DEVIATION REQUEST AND DECISION FORM

Project Name : Struthers Ranch Retail Center
 Schedule No.(s) : 7136303010, 7136303011, 7136303012, and 7136303013
 Legal Description : Replat of Lots 1, 2, 3, and 4, Struthers Ranch Subdivision Filing No. 4

A deviation from the standards of or in Section **2.3 Roadway Design** of the Engineering Criteria Manual (ECM) is requested. Applicable figures from the TIS report are attached as exhibits. Please refer to the TIS report for complete details.

2.3.2 - No access permitted to an Urban Minor Arterial Table 2-7

Figure 2
Site Plan

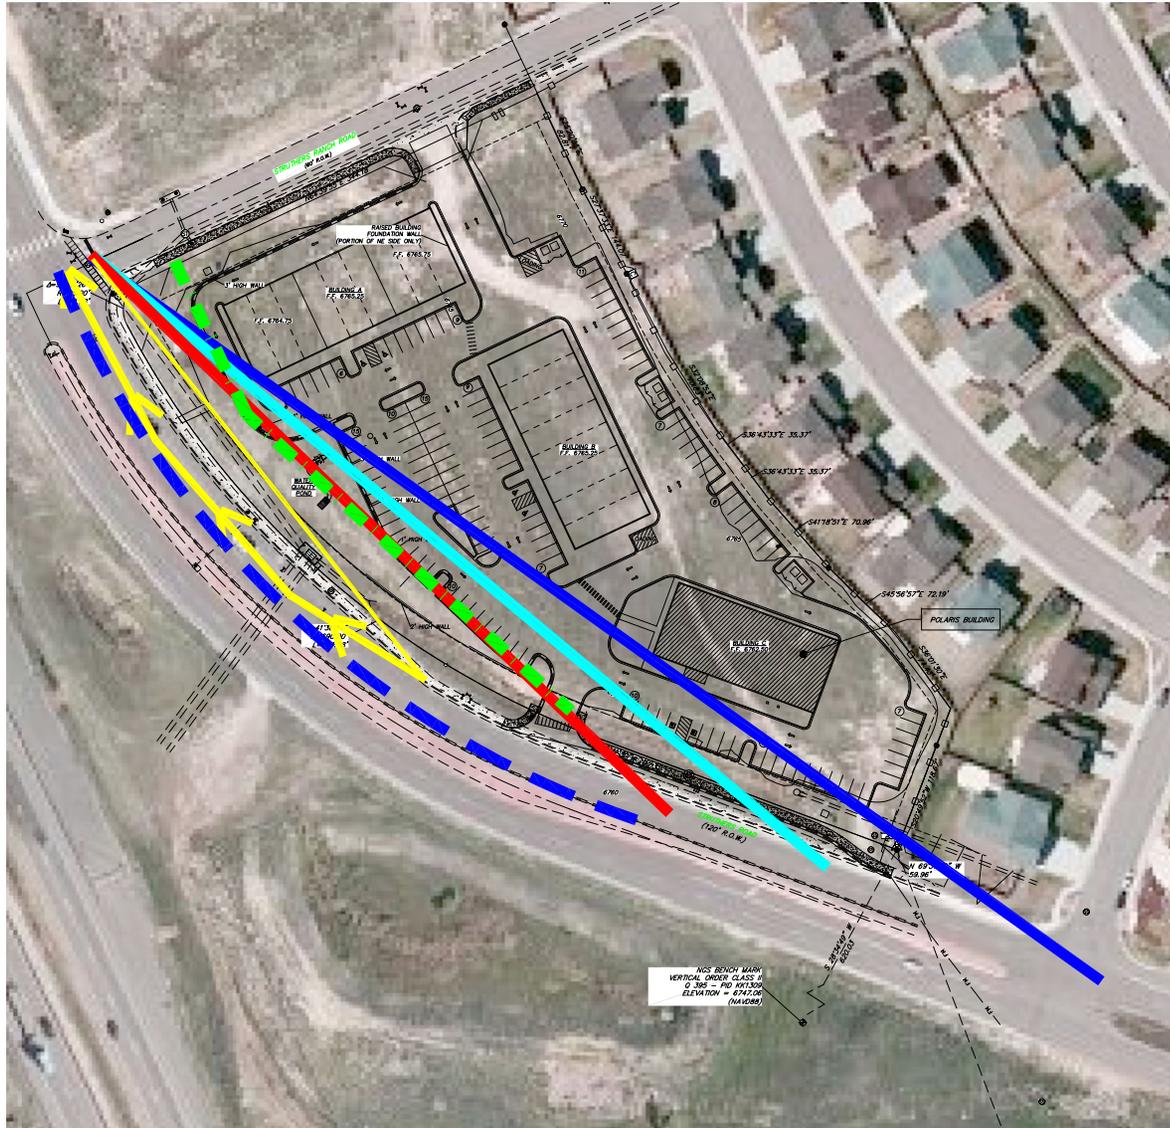
Install a Right-in/Right-out access point on northbound Struthers Road 560 feet south of Struthers Ranch Road. The access would include a northbound right turn deceleration lane. The comparison to the ECM standard is no direct parcel access is allowed to a Minor Arterial.

Adequate justification has not been provided for this request.
Recommend request to the Planner for allowance of a variance for the landscape requirements to move the required plantings to the east side of the site to provide for additional plantings between SF homes and this site.

Exhibit 2
**Line of Sight for
 Intersection Sight Distance
 (Struthers Ranch Rd to/from the south)**

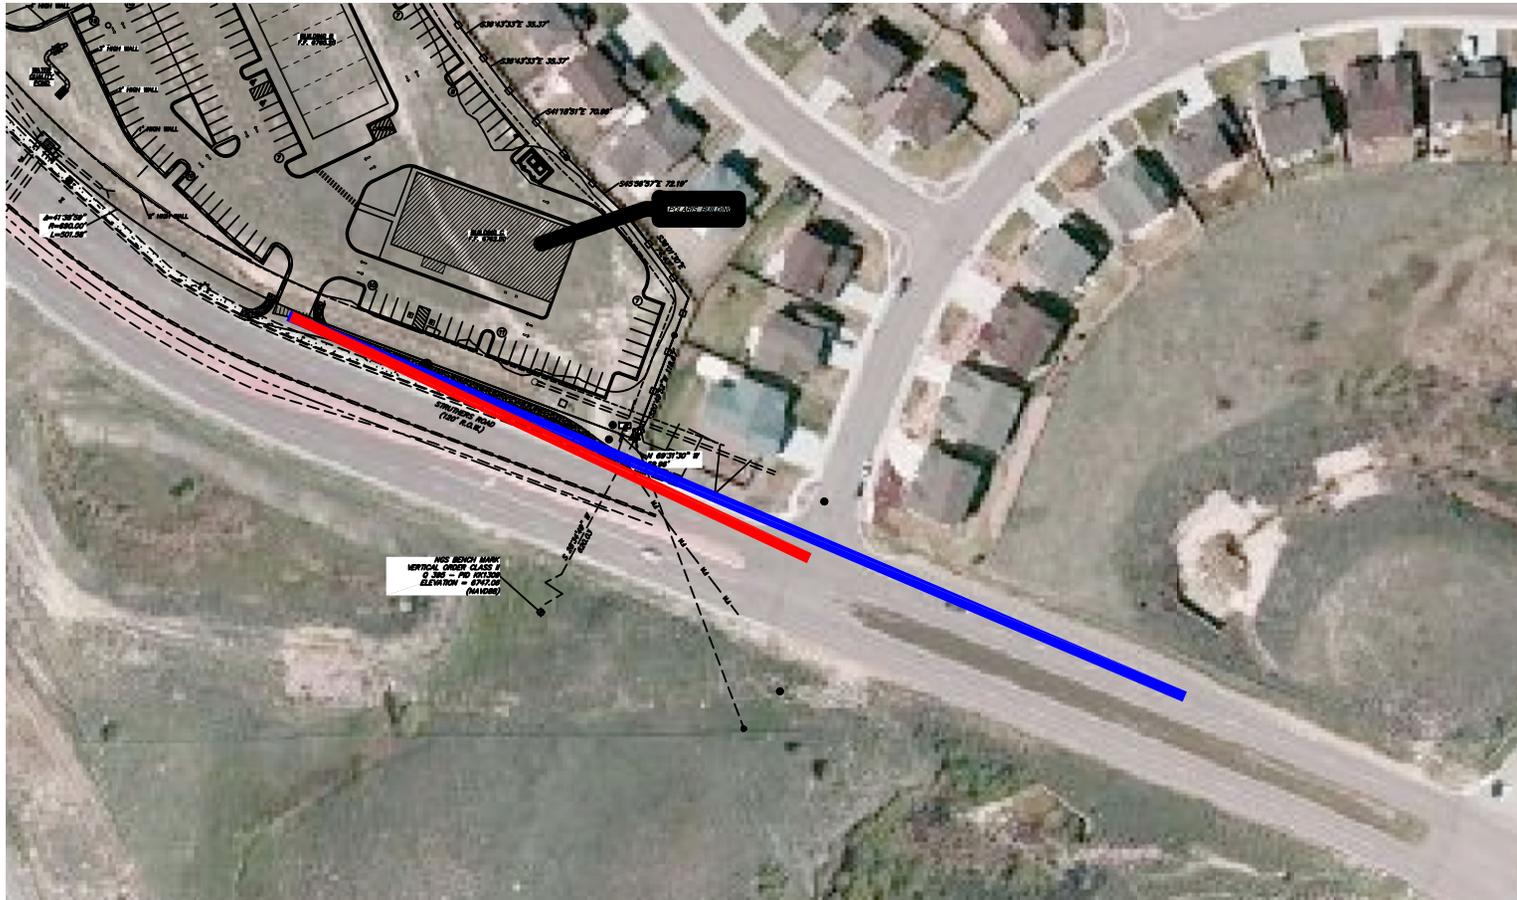
A new Right-in/Right-out access point along Struthers Road will provide significantly better access and circulation that the commercial center business owners need and patrons would benefit from. It would also provide a 2nd access point to the development for emergency vehicles. The site is on the inside of a horizontal curve on Struthers Road. It would be difficult to ensure adequate line of sight for intersection sight distance for trucks from the Struthers Ranch Road/Struthers Road intersection across the inside of this horizontal curve if the only access were to Struthers Ranch Road. The line-of-sight easement required for multi-unit trucks would cut across the middle of the site, which would be significant hardship to the applicant. Allowing the right-in/right-out would allow for a location for trucks to exit the site and turn onto Struthers Road with sight distance to the south meeting the full ECM entering sight distance criteria. Please refer to the sight distance analysis in the TIS Report.
